Nicholls State University

**ADDENDUM NO 1
FOR**

**BID SB01916
Procurement of Custom Baseball Stadium Padding
NICHOLLS STATE UNIVERSITY
THIBODAUX, LOUISIANA
10/02/2025**

Shorter right field wall constructed of metal

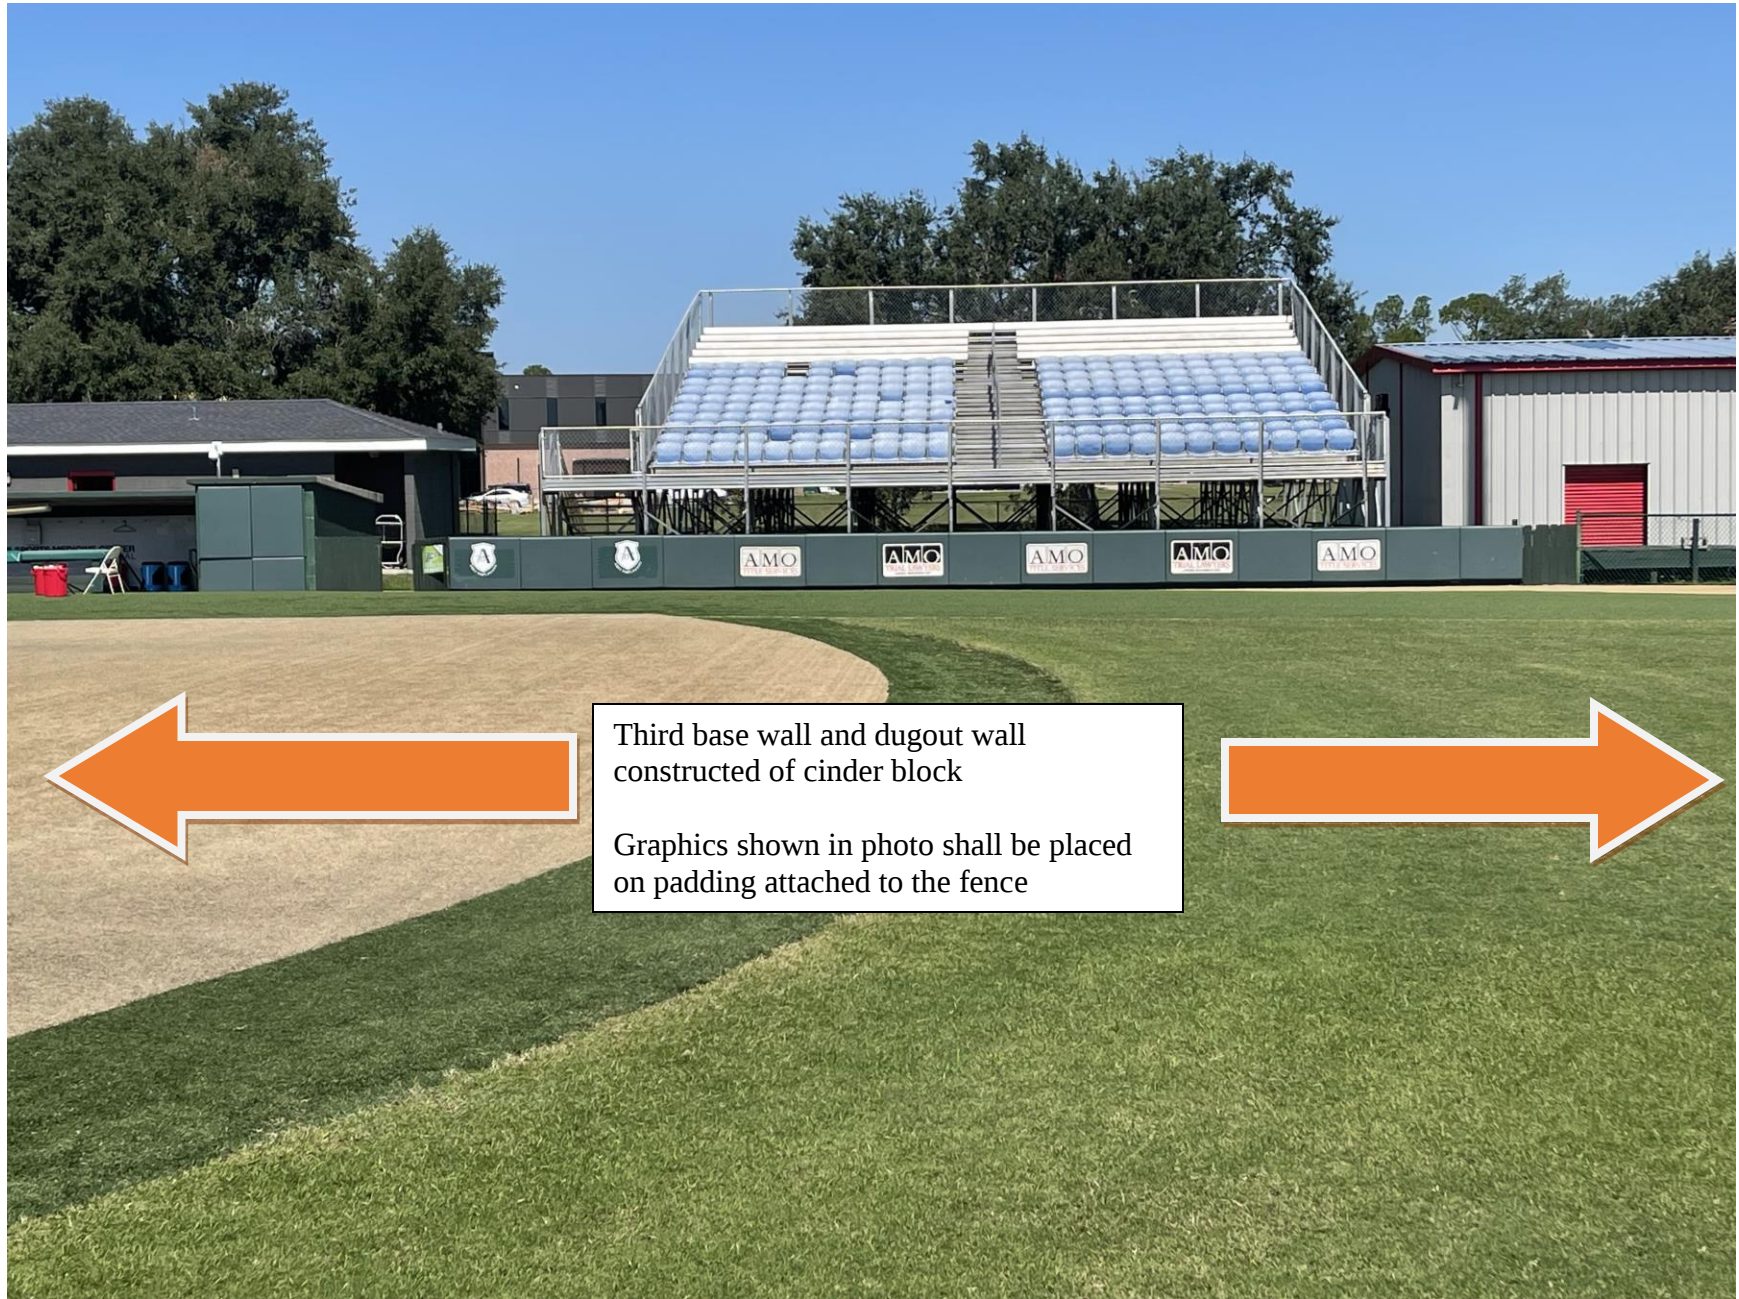
Sponsor graphics shown in photo shall be on the new pads attached to this wall

Third base wall and dugout wall
constructed of cinder block

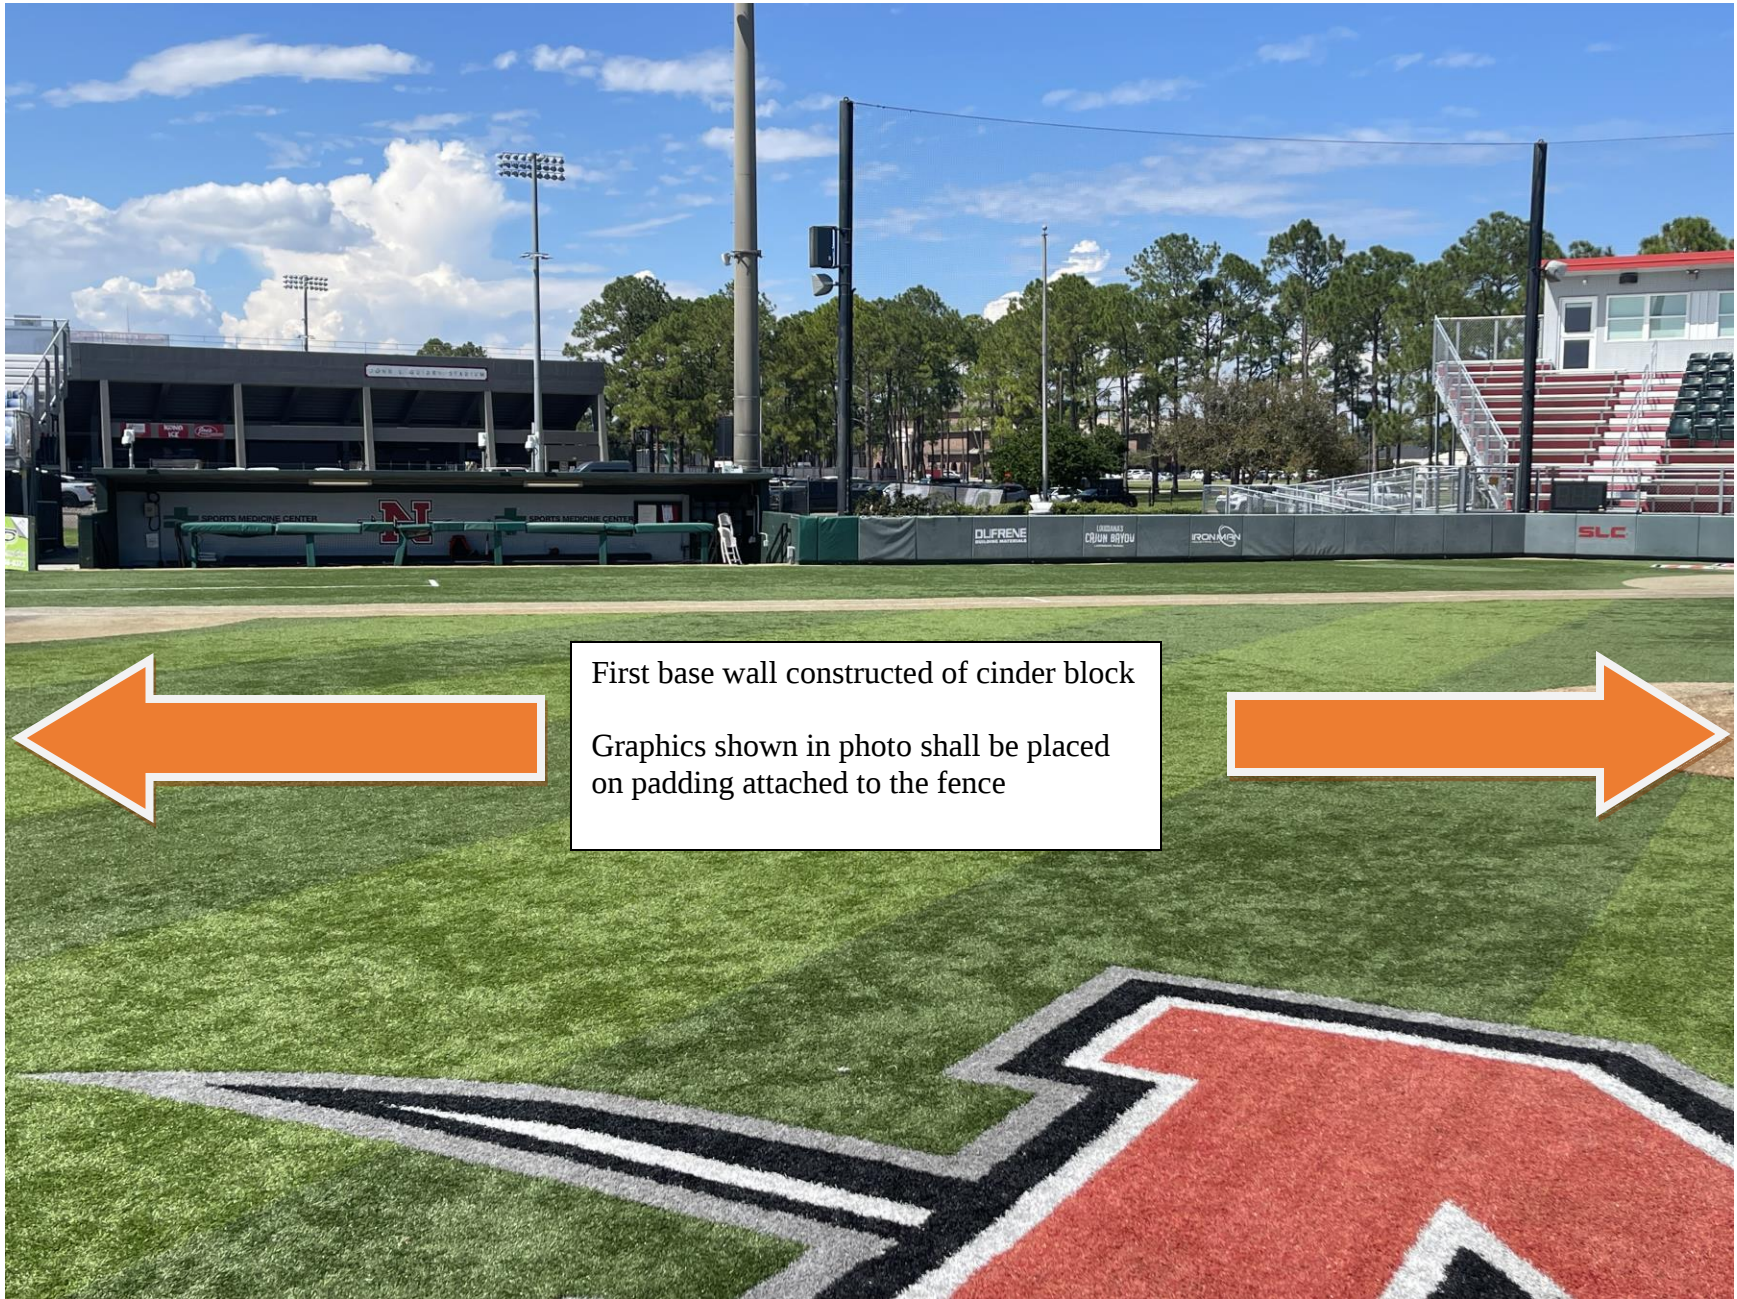
Graphics shown in photo shall be placed
on padding attached to the fence
